City of Glendale Community Development Department Design Review Staff Report – Multi-Family

Meeting/Decision Date: May 2, 2024	Address: 230 Winchester Ave, 91201								
Review Authority: □DRB ⊠ADR □HPC □CC	APN: 5626-011-016								
Case Number: PADR-001029-2023	Applicant: Amir Kacem								
Prepared By: Chloe Cuffel, Planner	Owner: Aleksandr Rostomyan								
Project Summary The project proposes a new 2,040 square foot (SF), two-story, residential dwelling unit with an attached two-car garage at the rear of an existing 1,464 SF single-family dwelling (built in 1937) located on a 7,500 SF lot in the R-3050 H (Moderate Density Residential) Horse Overlay Zone.									
Existing Property/Background The subject site is a 7,500 square-foot corner lot that wa Minimal Traditional house and a detached garage access the site. The site topography consists of relatively flat to the other properties in the neighborhood. The site is on Riverside Drive and South Victory Boulevard in the River context surrounding the subject site features mostly sing subject site and several multi-family and commercial but the alley.	ssed from the existing alley on the northwest side of errain and has a regular,

LEGEND/ NOTES / DOOR & WINDOW SCHEDULE

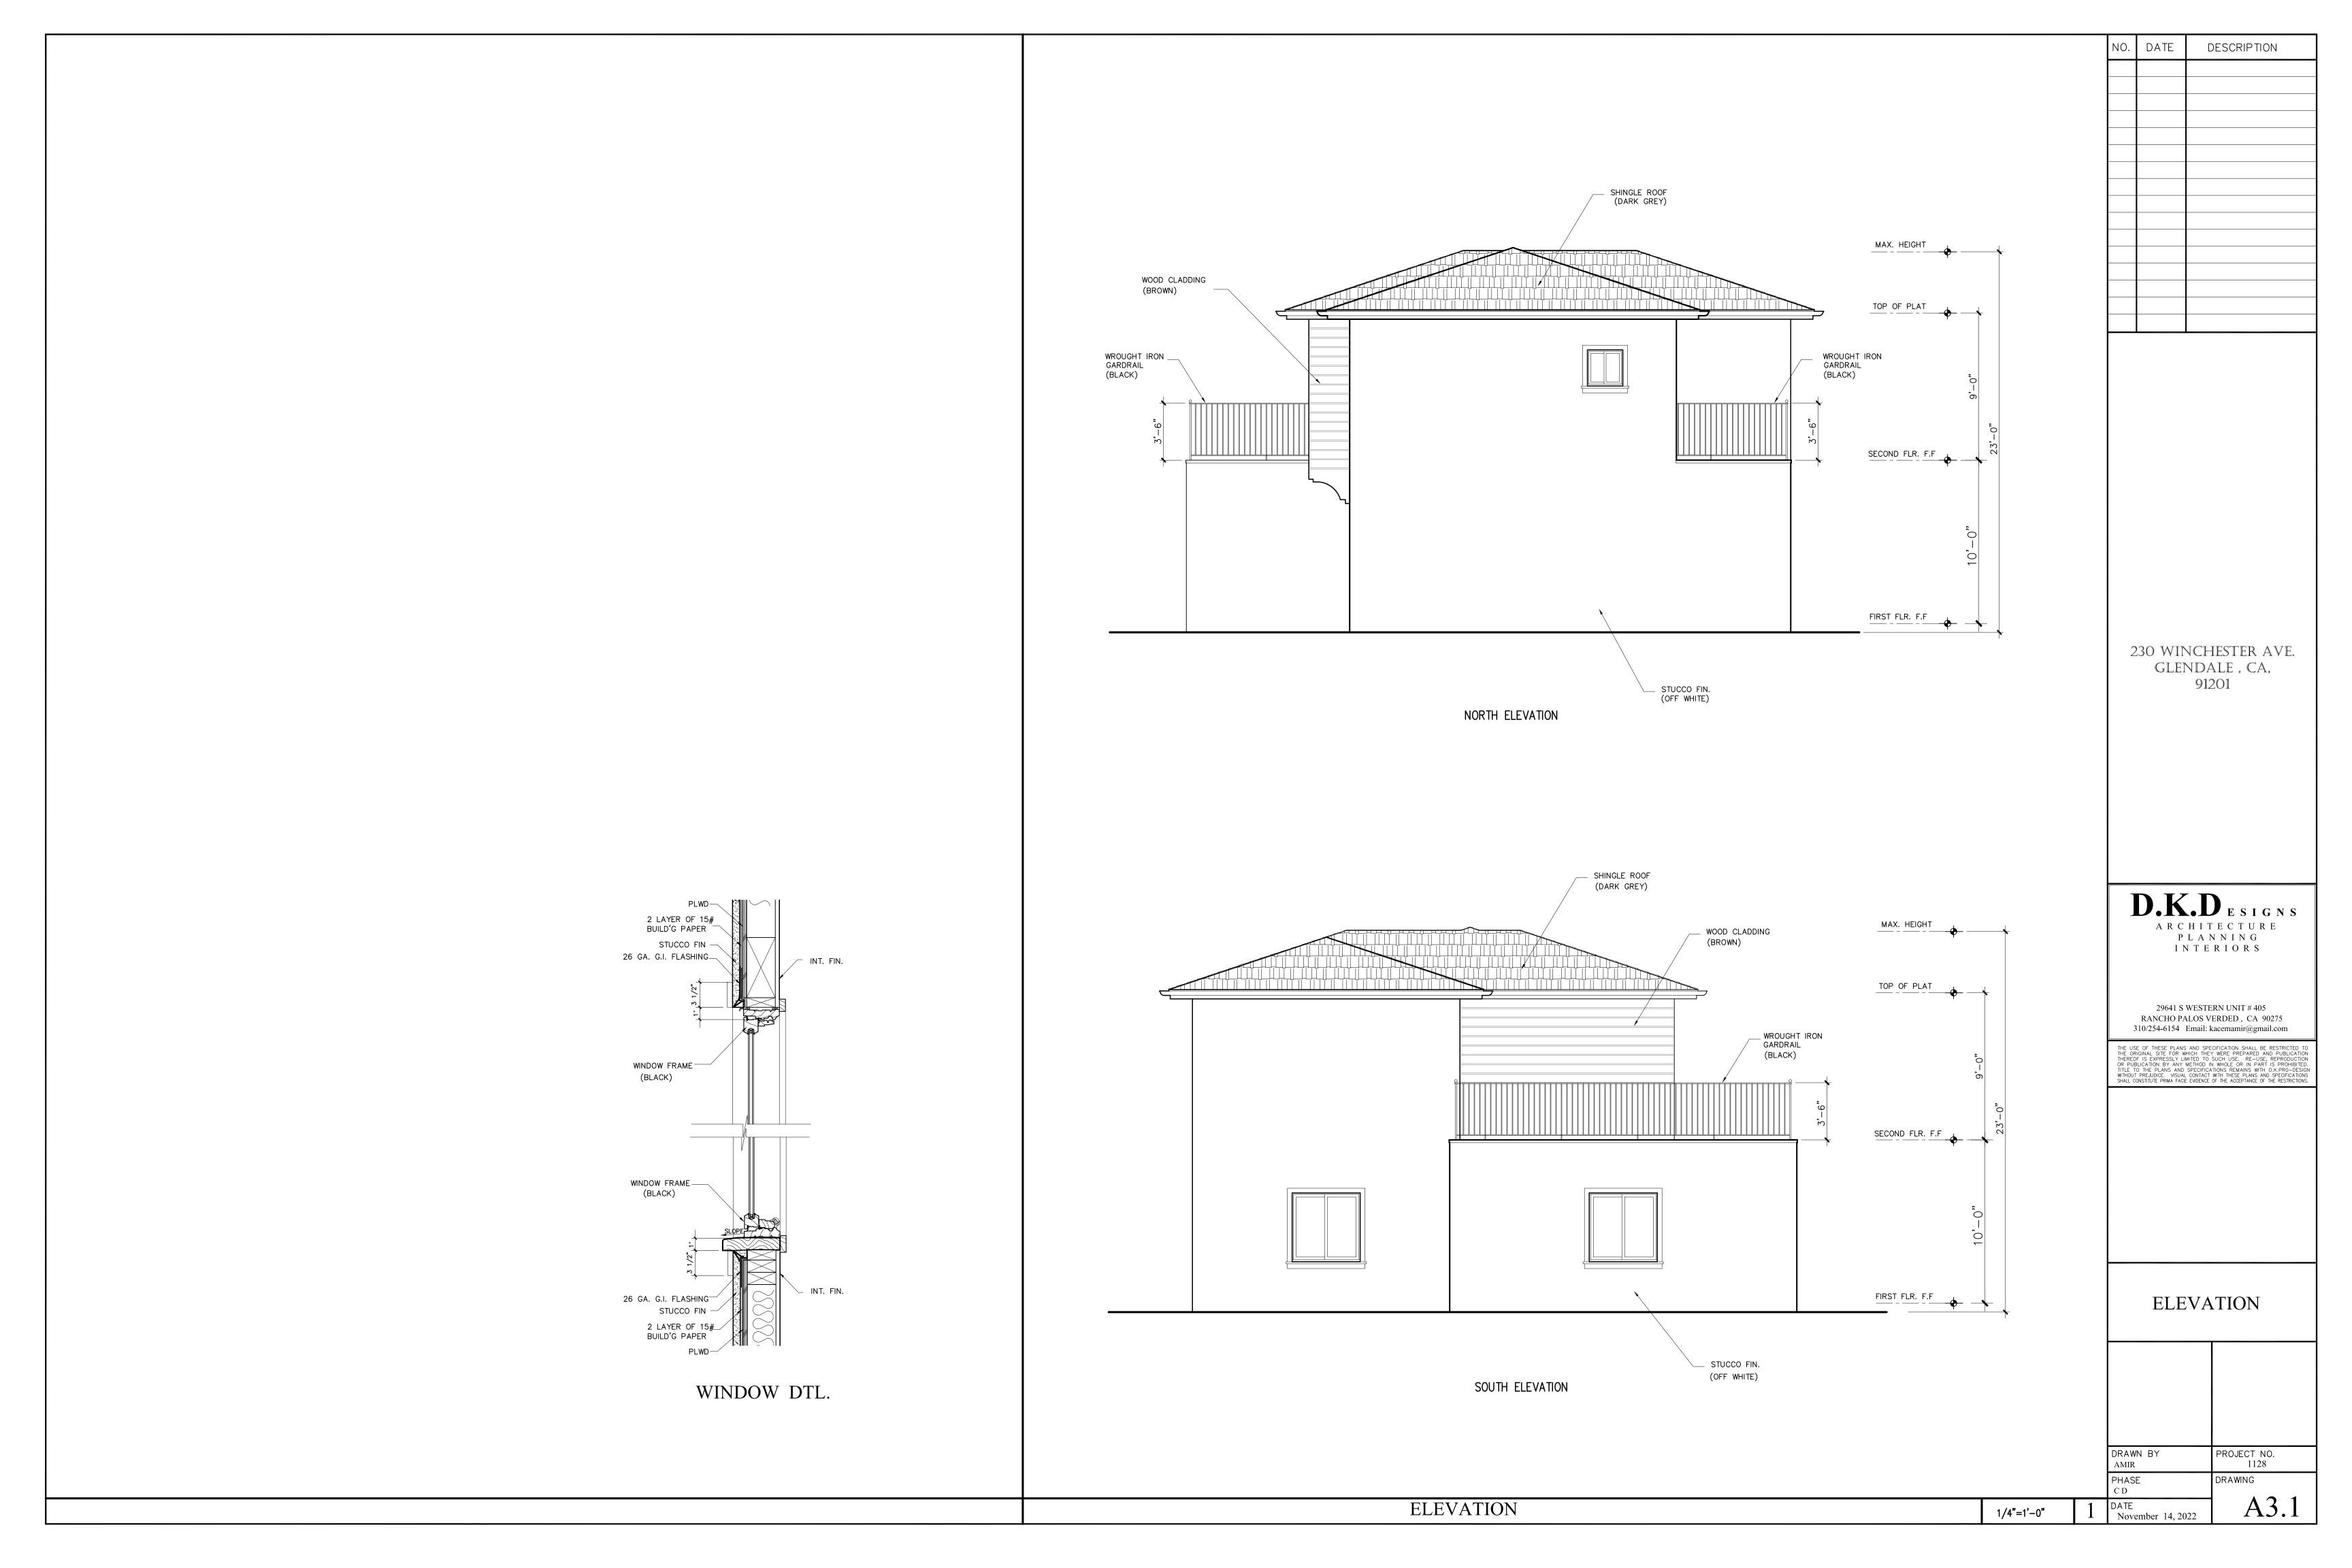
esign and Detailing e the following items satisfactory and compatible with the project site and surrounding area?
Overall Design and Detailing ⊠ yes □ n/a □ no
If "no" select from below and explain: □ Design is compatible with neighborhood context □ Design is stylistically consistent □ Employs consistent vocabulary of forms and materials while expressing architectural variety □ Cladding materials and
Entryway ⊠ yes □ n/a □ no
If "no" select from below and explain: □Well integrated into design □Avoids sense of monumentality □Design provides appropriate focal point □Doors appropriate to design
Windows ☐ yes ☐ n/a ☒ no
If "no" select from below and explain: □ Appropriate to overall design □ Overall window pattern appropriate to style □ Window operation appropriate to style □ Recessed/flush window appropriate to style and/or location □ Openings are well detailed The new development features sliding windows. A condition has been included to revise the window schedule to use Fixed, Casement, or Hung windows.

- 1. Include spec of proposed gate along the alley to ensure it is compatible with existing wood fence.
- 2. Provide location of trash storage that is out of public view for staff review and approval.
- 3. Revise plans to show the location of all proposed site lighting and light fixtures on the building limited to the main entry and patio doors, and show downspouts on the building, finished to match the adjacent wall color for staff review and approval.
- 4. Revise window schedule to replace Sliders with Casement, Fixed, or Hung operation to meet the Window Guidelines.
